PRODUCT/PROCESS CHANGE NOTICE (PCN)

PCN #: SM-0504-03	DATE: April 6, 2005	MEANS OF DISTINGUISHING CHANGED DEVICES:
Product Affected: BF/BFG 100 (Refer Attachment II for the affected part numbers)		<input type="checkbox"/> Product Mark <input type="checkbox"/> Back Mark <input type="checkbox"/> Date Code <input checked="" type="checkbox"/> Other Change in unit quantity per tray
Date Effective: May 2, 2005

To change new revision of tray with different tray matrix for BF/BFG100. Tray is compliant to JEDEC 95 Standards. Tray size (outside dimensions) will remain the same. New revision of tray provides better pick & place process on equipment.

TRAY DRAWING I

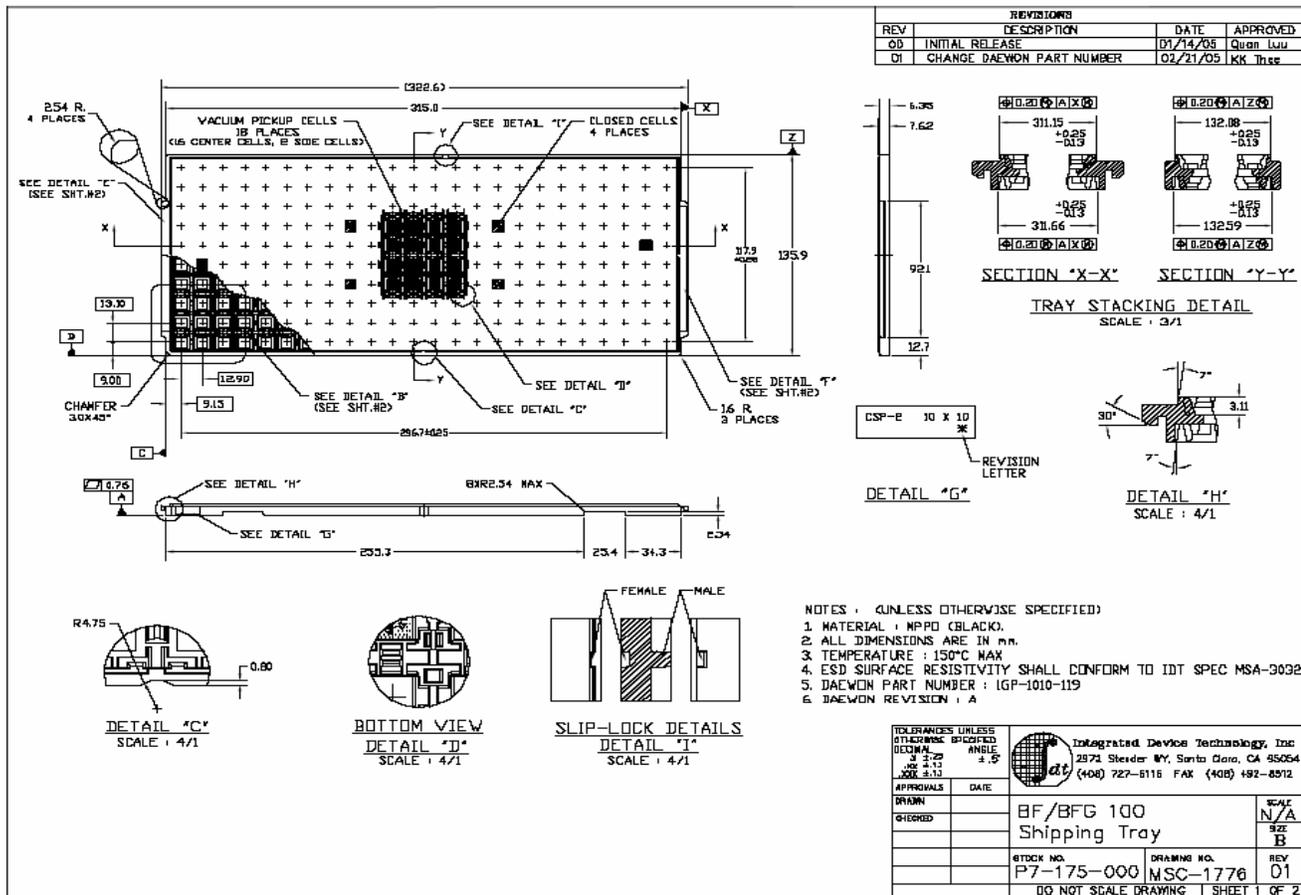
Description	Current Tray	New Tray
IDT Drawing# :	MSC-1703	MSC-1776
Quantity Per Tray :	250 units	240 units
Pocket Size :	10mm x 10mm	10mm x 10 mm
Tray Matrix :	10 x 25	10 x 24
